# Delegated Report

## Householder Planning Application

**Planning Application No:** 20230499

**Description:** Erection of a single storey rear extension with part two storey extension over and rooflights to front roof slope together with conversion of existing garage into day / garden room.

GBC Highways Officer:

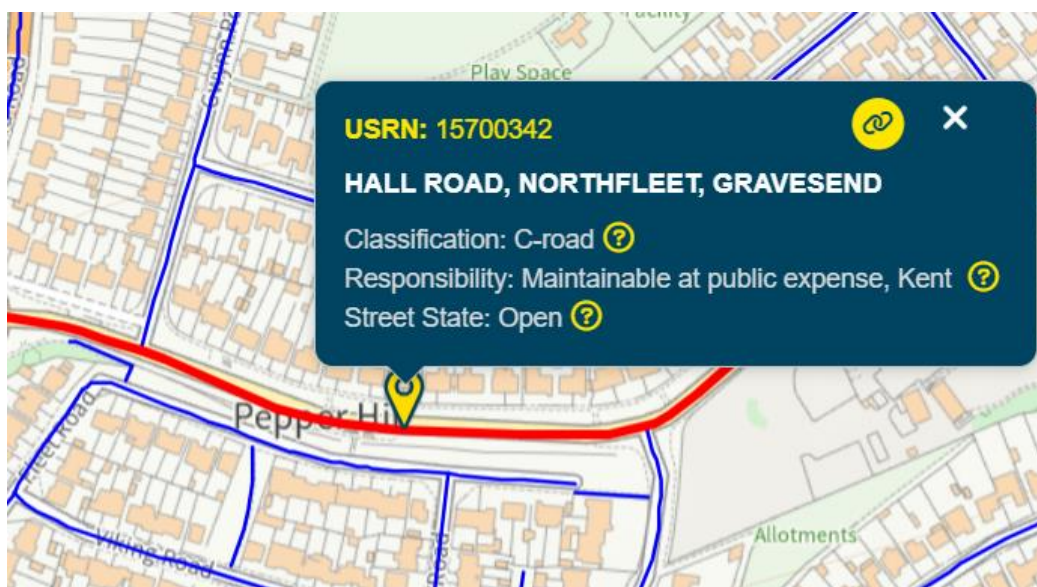
This application requires very careful consideration due to the existing situation and the proximity of the service road junction with Gwynn Road and the distance between the service road and Hall Road.

First the garage at the rear of the property, its loss would be ideal, as currently the garage is located at the back edge of footway and so has no pedestrian visibility splays and unless it is fitted with a roller door the door would open out across the footway. Section 153 of the Highways Act 1980.

<https://www.legislation.gov.uk/ukpga/1980/66/section/153>. However, the pedestrian door to Gwynn Road should not be permitted or a suitable condition imposed to prevent the garden room becoming a habitable room, as the garden room could be used as a dwelling with all the facilities it is being provided with. (Kitchen and shower/wc room)

With four bedrooms two car parking spaces should be provided and these can be within the front garden, although the proximity of Gwynn Road gives some concern. However, providing any boundary treatment, hard or soft landscaping are limited to below 850mm in height visibility of pedestrians and vehicles can be improved and be better than the existing situation. It should also be noted that the applicant could pave the front garden in a permeable material without the benefit of planning permission if my understand is correct, and there is no kerb to prevent access although the applicant should check with Kent County Council, that the footway fronting the property has been suitably strengthened to accommodate vehicles crossing it without damage.

Given the works to the front garden could I believe be carried out without planning permission, it is better to have some control over the boundary treatment to improve highway safety and the loss of the garage at the rear of the property can only be considered a benefit.

I have no objections, subject to there being a restriction on the height of any boundary treatment, hard or soft landscaping to a maximum height of 850mm above footway level in the front garden and the new driveway is constructed from a bound permeable material installed in accordance with the manufacturer's specification.

In addition, a suitable condition should be imposed to ensure the garden room cannot be used as a habitable room, as it could easily become an independent dwelling with the door directly on to Gwynn Road, or the door to Gwynn Road is deleted from the scheme.

An informative should be added that the front garden is only considered to be suitable for the parking of two cars, as it is doubtful that a condition restricting the drive to two vehicles would be enforceable.
